Subject: RE: NYM/2022/0249 Land Adj Low Farm Beacon Way Sneaton E11107-36 Client
08.06.22

Please see attached the drawings amended following your comments of the 13th May. These drawings are intended to provide information to address your points; 1, 3, 4, 5, 7, 8, 10 and 11.

CLIENT:	Mr Stainthorpe
PROJECT:	Low Farm Sneaton
Drawing:	Scheme one Proposed Block Plan
DRAWING STATUS:	Preliminary
DRAWN:	C Eynon
CHECKED:	N I Duffield
SCALE @ SIZE:	1:200@ A1
DATE:	15/06/17
DRAWING No:	D11107-03
REV:	I

CLIENT:	Mr Stainthorpe
PROJECT:	Low Farm Sneaton
DRAWING:	Proposed Outbuildings Store/Studio Plans and Elevations
DRAWING STATUS:	Preliminary
DRAWN:	C Eynon
CHECKED:	N I Duffield
SCALE @ SIZE:	1:100&1:50@ A1
DATE:	05/04/22
DRAWING No:	D11107-13
REV:	B

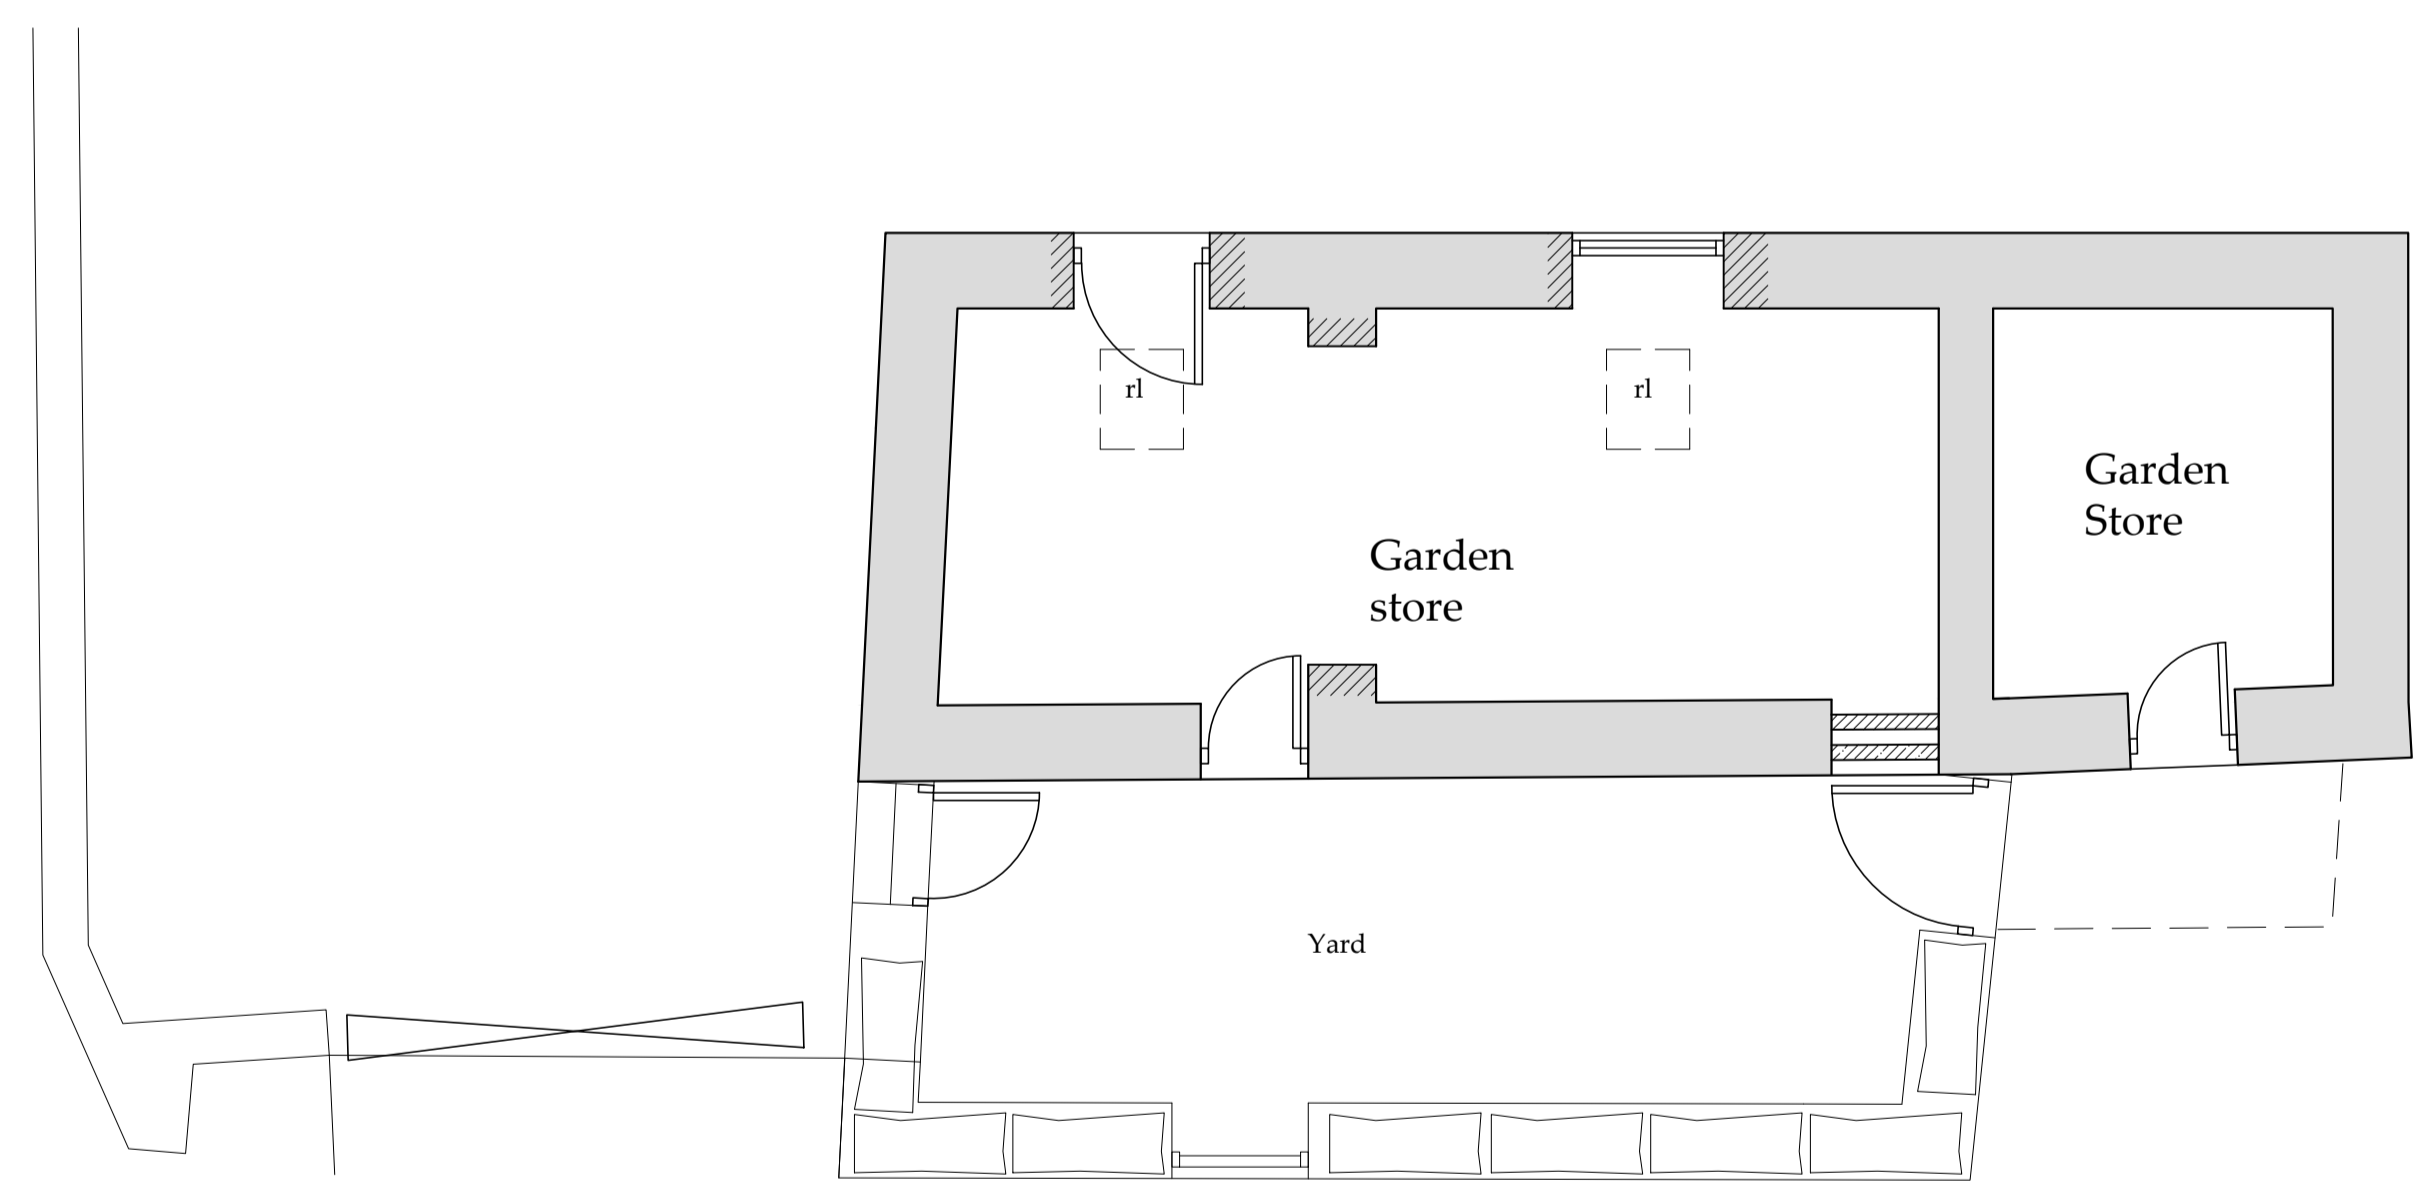
Item 11, drawing -13b shows the floor plan of what will be a **garden Store**, linked to Cottage 6.

Item 11- The existing studio/store to the rear of unit 6 is simply to be utilised as a garden store and the labelling on the proposed plans has been changed to reflect this.
